NOTICE OF DECISION

CLASS 3 SITE PLAN REVIEW / CLASS 2 ADJUSTMENT / CLASS 1 DESIGN REVIEW CASE NO. SPR-ADJ-DR20-21

SUMMARY: A proposal for a new six-unit multi-family complex.

LOCATION: 1795 Fairgrounds Road NE

Proposed Site Plan

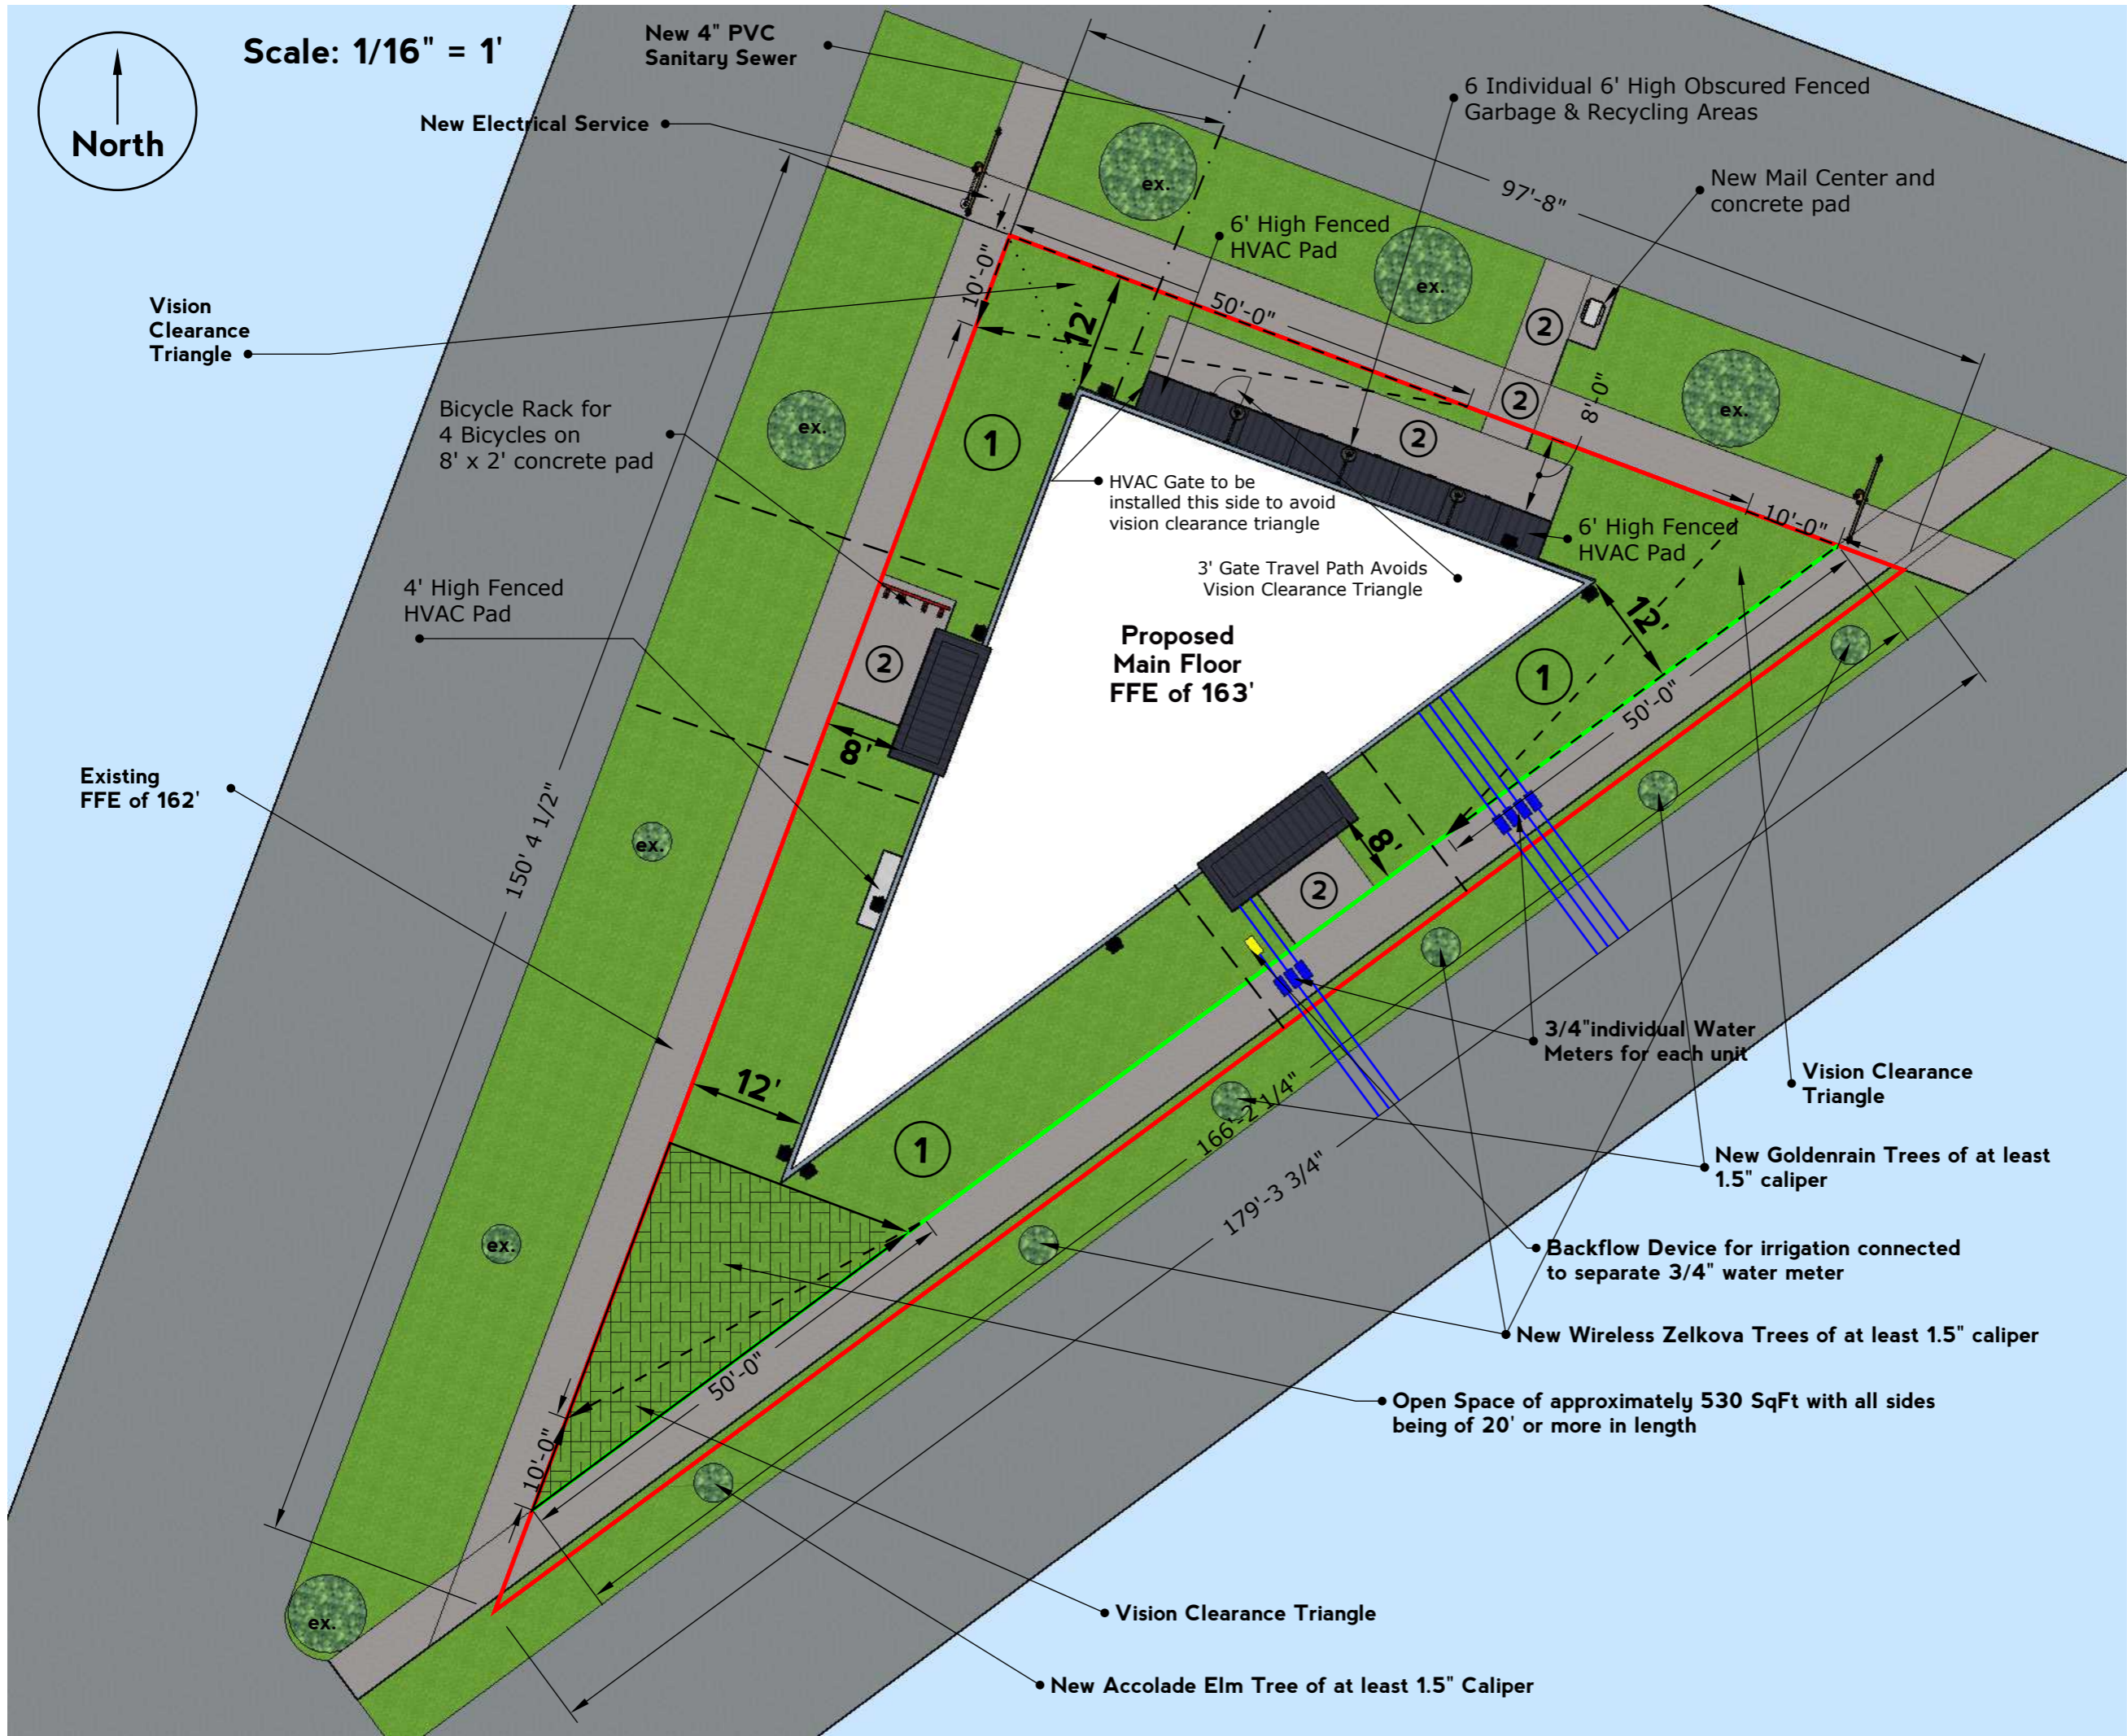
Finding: The applicant has provided window in each habitable room in each unit. The windows overlook, common open space and the public sidewalks. As described below in the adjustment section, the public sidewalks will be used for pedestrian paths to solid waste disposal area and the common open space. Since the public sidewalks will be used as the pedestrian paths, the windows are to encourage visual surveillance of those areas. The windows will need to be large enough and at a height to encourage the surveillance of those areas. As conditioned below, the applicant will need to modify windows facing Madison Street to allow residents to visually survey the areas. The written statement indicates that lighting will be provided around the subject property and near the solid waste areas.

Finding: The site plan indicates a bicycle rack with four spaces within 50 feet of a building entrance, but the rack does not appear to meet the current standards in Figure 806-10. The following condition ensures that the minimum bicycle parking requirement of four spaces shall be met at the time of building permit.

Finding: The existing condition of Fairgrounds Road NE does not meet current right-of-way standards for its classification of street per the Salem Transportation System Plan. Dedication a half-width right-of-way up to 36 feet to Minor Arterial street standards and adequate right-of-way at the property corners as specified in the Public Works Design Standards.

Condition 1: At the time of building permit, four bicycle spaces shall be provided meeting the development standards of SRC 806.

Condition 2: Convey land for dedication to equal a half-width right-of-way of 36 feet on the development side of Fairgrounds Road NE and sufficient right-of-way to accommodate public infrastructure at the property corners.

Condition 3: Remove the existing sidewalk and construct sidewalk parallel to and one foot from the adjacent right-of-way along the Fairgrounds Road NE frontage of the property.

Condition 5: The north side of the proposed building shall have windows in each habitable room. The base of each window shall be no taller than five feet from the floor and at least six square feet in size.
